**From:** [Craig Omtvedt](#)  
**To:** [Margaret Zeidman](#); [Lew Crampton](#); [Gail Coniglio](#); [Bobbie Lindsay](#); [Julie Araskog](#); [Kelly Churney](#); [Richard Rene Silvin](#); [Wayne Bergman](#); [Steven Stern](#)  
**Cc:** [Martha Schar](#); [Charlotte Lowe](#); [Charlotte Beers](#); [Greg Dryer](#); [Sarah Soter \(srsoter@gmail.com\)](#); [Jill Glazer](#); [ellencunningham@mac.com](#); [susanisbishop@gmail.com](#); [Peter wood](#); [Adam Bulmer](#); [John Preston](#); [cochran63@mac.com](#)  
**Subject:** Fwd: Transformer Easement  
**Date:** Tuesday, July 07, 2020 5:03:52 PM

Subject: Transformer Easement

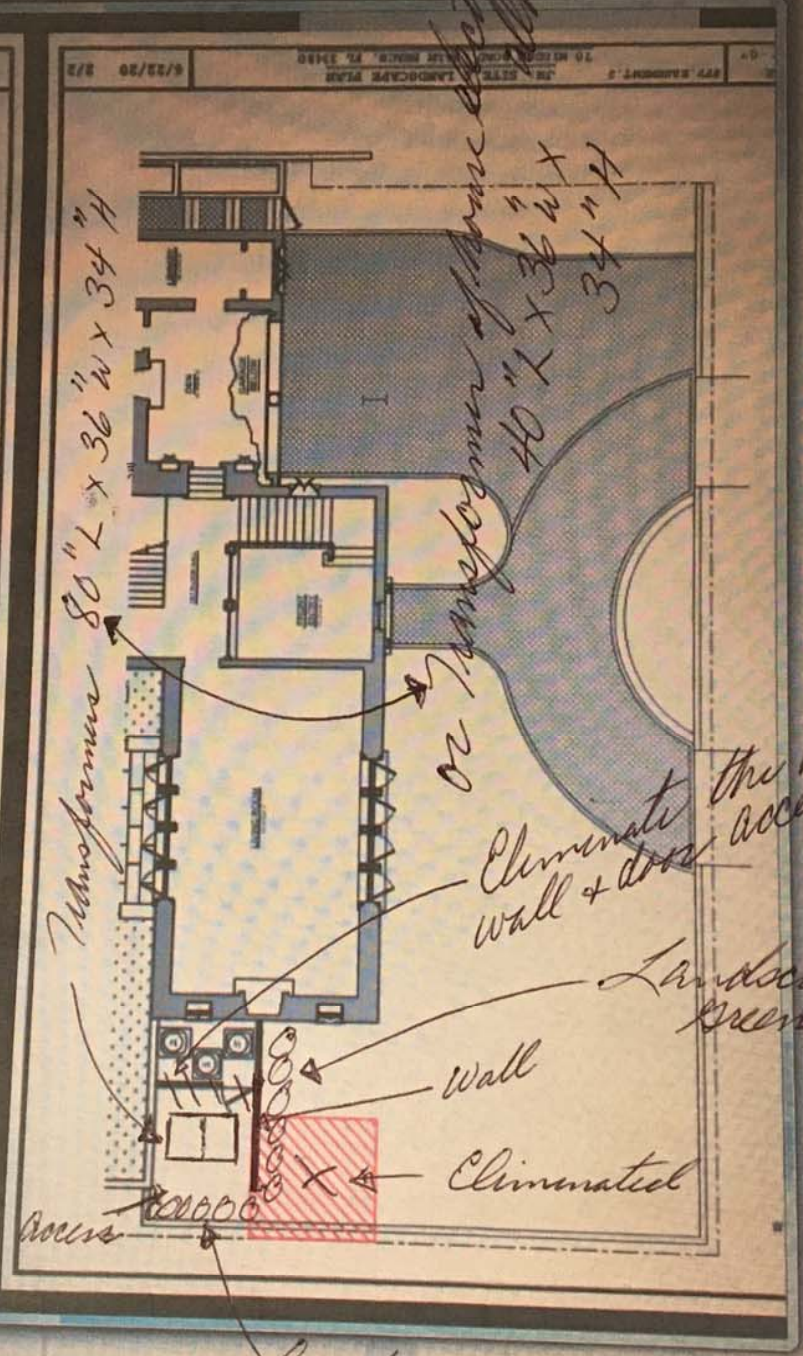
1. Your drawings are a gross exaggeration of what is needed. The 12'x13' you continue to reference is both the transformers and work space requirement.

The worst case space requirement for the actual transformers is 80"L x 36"W x 34"H. If you would take the time to get an electrician out to check your electrical panel and needs, it could be that you could have your meter replaced

with a more current meter and only need a single phase transformer 40"L x 36"W x 34"H. Note attachment showing proposed placement of transformers in a partially enclosed area with your air conditioning units. Also note elimination of easement space as shown.

RETOWN COUNCIL MEMBERS ARE NOW THREATENING THAT THEY CAN OPT TO "DENY" THE REQUEST FOR 5 VARIANCES.  
mail.google.com/mail/u/0/?ui=2&view=bt&ver=1nj101dboqm98&msg=%23msg-#%3A16703276214314329798&att...  
PROPOSED BY TPB(FPL AND KIMLEY-HORN)

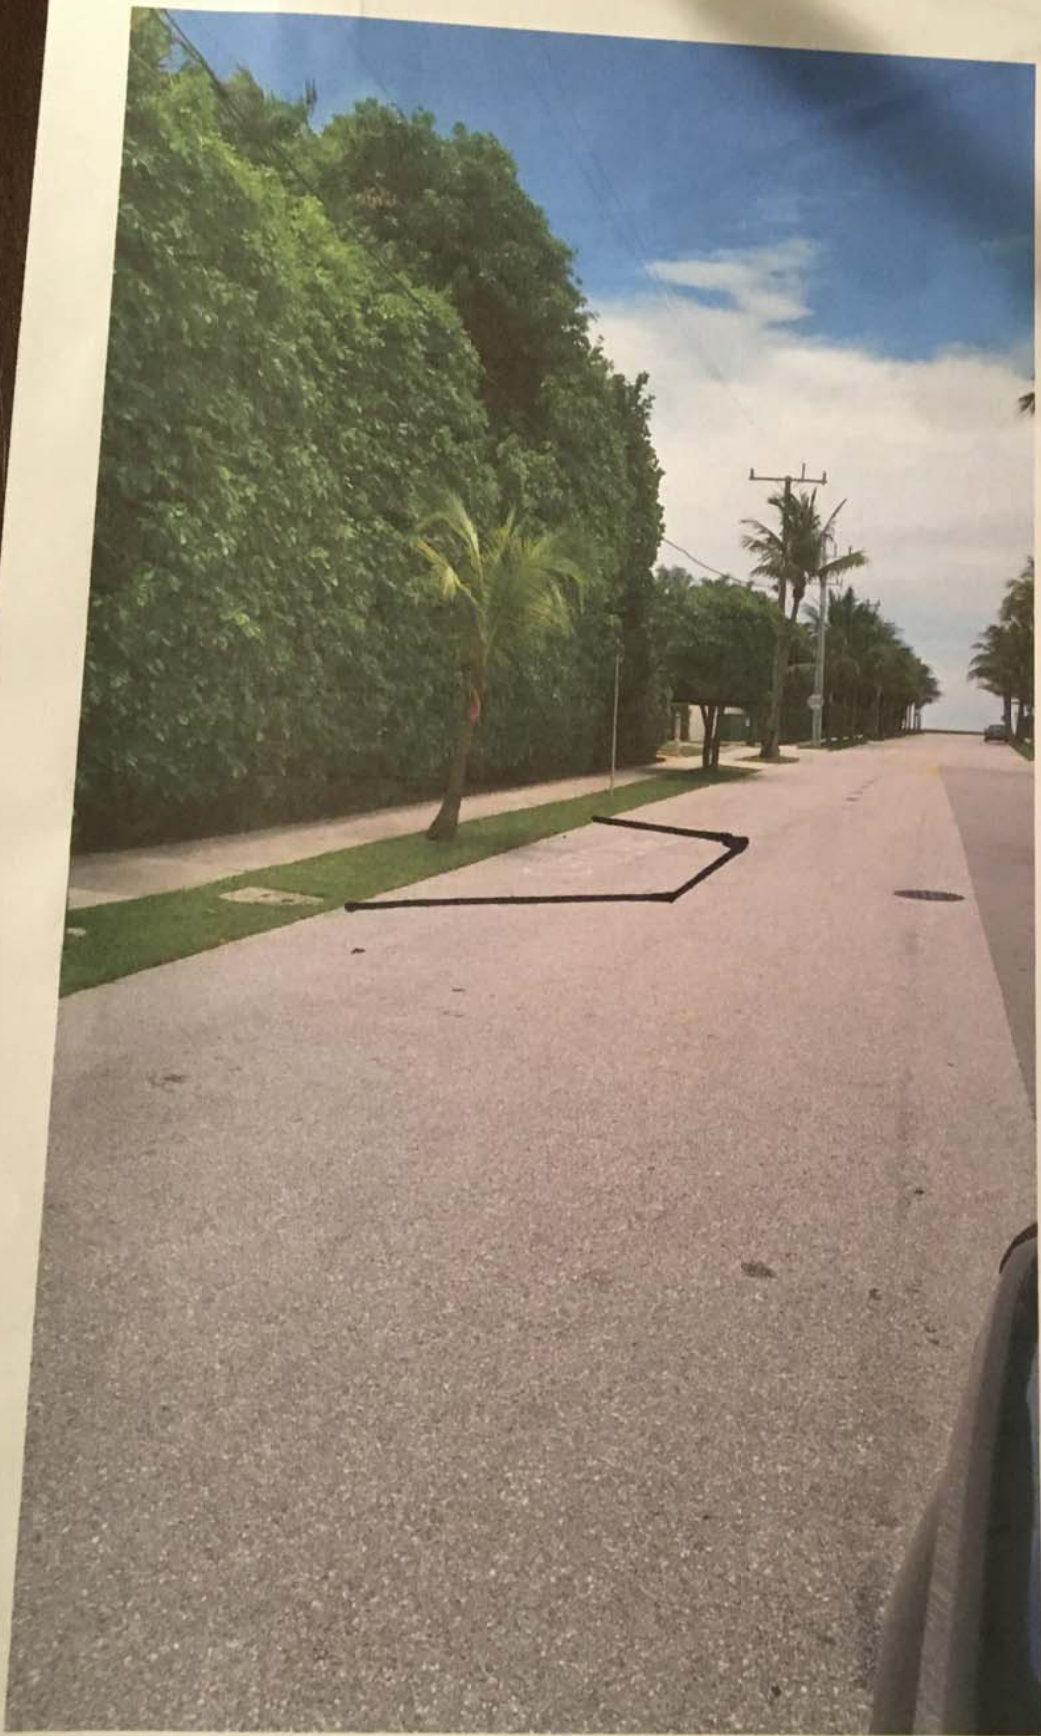
\* Last  
resort  
Chucane  
for  
70  
Middle  
Rd.  
Transformers  
or  
Transformer
